Determination 2010/097

Safety barriers to a swimming pool and a spa pool at 17 Banks Road, Matamata

Figure 1: the swimming pool and spa pool areas

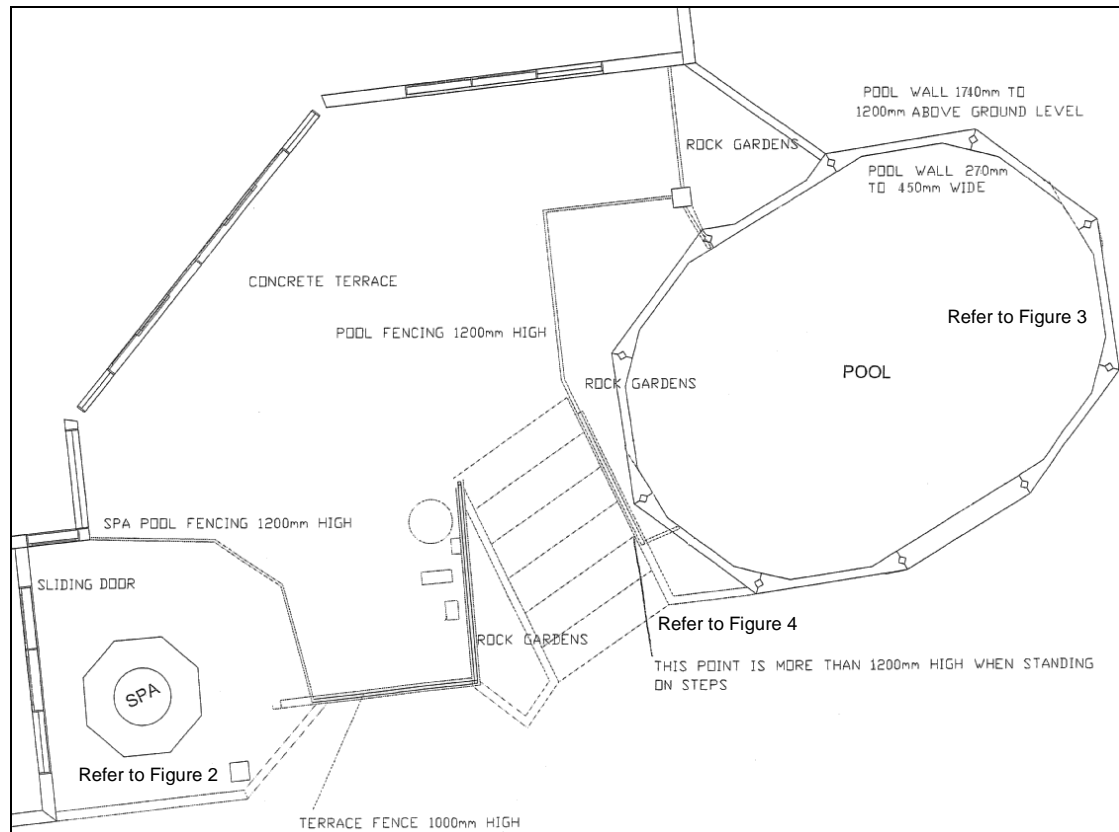
- 6.5 For the reasons set out above I conclude that the spa pool barrier, which includes a sliding door, does not comply with Clause F4 of the Building Code as it does not restrict the passage of children under the age of six.

- 8.17 I conclude that the swimming pool wall does not comply with Clause F4.3.1.

- The ground level below the pool wall is to be built up so that it is an even 1.2m all the way around. This is to be done either by building up and then sloping away the ground level, or building a small retaining wall and infilling the area between this and the pool wall. In either situation, the width of the area that is 1.2m below the top of the wall should be around 1m. This area should be not be concreted or paved, but should be maintained as a grass area or garden, provided the garden doesn't contain items that could compromise the safety of the 1.2m wall in terms of restricting the access of children under the age of six years old.

- The section of the swimming pool wall that runs alongside the steps from the terrace to the garden is to be fenced along its entire length. At present, this section of wall is only partially fenced and there is a risk that a person could fall off the wall onto the concrete steps below.

- Additional fencing is to be added so that people inside the current fencing cannot walk from the terrace onto the pool wall. This could be achieved by adding batters or wings onto the current fencing in such a way that they block access onto the wall (as described in paragraph 8.9).

Figure 2: the interior of the spa pool enclosure showing the Hinuera stone detail at the corner of the house and connecting wall.

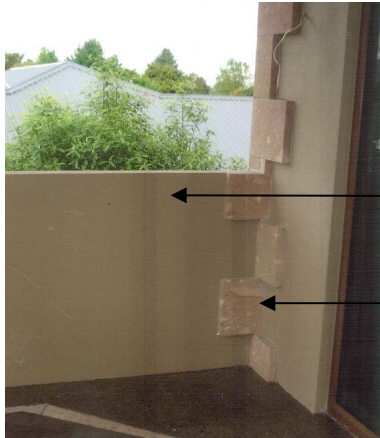
- 7.2 The authority has expressed concerns that the Hinuera stone detail in the wall could provide toeholds or steps that would enable a child to climb to the top of the wall, putting them at risk of falling to the ground on the other side.

- 7.3 The authority's concern was that the wall, as constructed, does not comply with Figure 3 of F4/AS1. In my view the matter at issue is not whether the barrier complies with the Acceptable Solution, but whether it complies with the requirements of the Building Code.

- 7.4 I consider that the spa pool area is an area unlikely to be frequented by children under the age of six, once the barrier to the spa pool area is brought into compliance with the Building Code; therefore the requirements of Clause F4.3.4(g) do not need to be met.

- 7.5 Assuming the barrier to the spa pool is brought into compliance with Clause F4 in respect of pool safety (refer paragraph 6), I conclude that the wall does not need to restrict the passage of children under the age of six, and as such it complies with the requirements of the Building Code with respect to safety from falling.

Figure 4: the swimming pool wall beside steps from the terrace to ground level

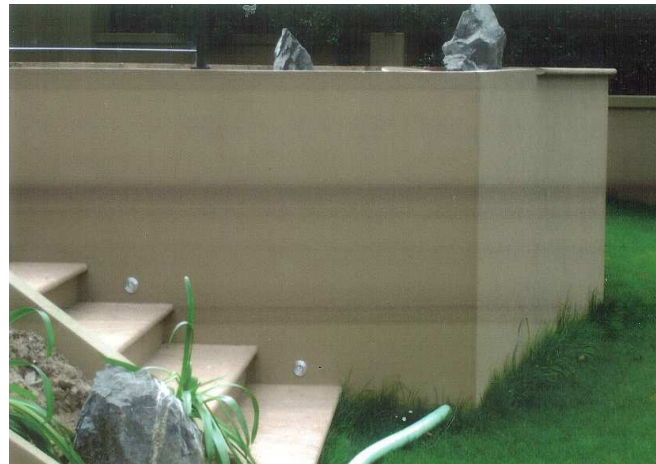
- 8.4 In their submissions the applicants relied upon an email from an advisor to the department on an unrelated matter, which indicated that, with respect to swimming pool walls, 'The general consensus seems to be that if a wall is less than about 350mm wide then there is no need to provide a barrier'. This email does not constitute guidance published by the Chief Executive of the Department under section 175, and cannot be relied upon as such. Instead it is general advice given by an officer of the Department to a territorial authority to provide guidance in a particular situation. I note also that in the current determination, the pool wall is in several places wider than 350mm.

- 8.5 At the hearing the applicants did not dispute that the swimming pool wall could be walked or sat upon. What they disputed was the degree of risk or possibility of someone falling off it. I consider that there clearly is a risk that both adults and children could fall off the wall. At its highest point the wall is 1.74m above the lawn below.
